ZONING AMENDMENT

<u>& SUBDIVISION STAFF REPORT</u>
Date: July 3, 2014

APPLICANT NAME Georgia Crown Distributing Subdivision

LOCATION Southwest corner of Shipyard Road and Crown Drive.

SITE PLAN

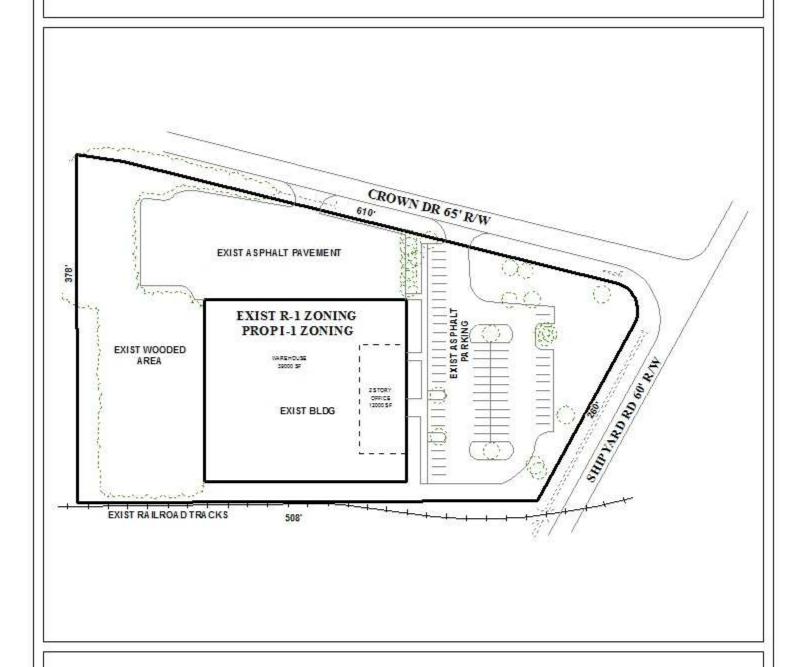
The lot size is not labeled in square feet and acres. If approved, revisions should be made to depict the lot size in square feet and acres on the Final Plat, or a table should be furnished on the Final Plat providing the same information.

The 25-foot minimum building setback line is not depicted on the preliminary plat. If approved, revisions should be made on the Final Plat to illustrate the 25' minimum building setback line.

A sidewalk is not depicted on the zoning site plan. Prior to any new development of the site, the applicant should submit a sidewalk waiver or provide a sidewalk at time of any new construction as required by the Subdivision Regulations.

- 1) retention of the right-of-way width of Shipyard Road and Crown Drive on the Final Plat;
- 2) illustration of the 25' minimum building setback line along Shipyard Road and Crown Drive on Final Plat;

- 3) the labeling of the lot with its size in square feet and acres, or the furnishing of a table on the Final Plat providing the same information;
- 4) prior to any new construction on the site, the applicant should submit a sidewalk waiver or provide a sidewalk at time of new construction as required by the Subdivision Regulations;
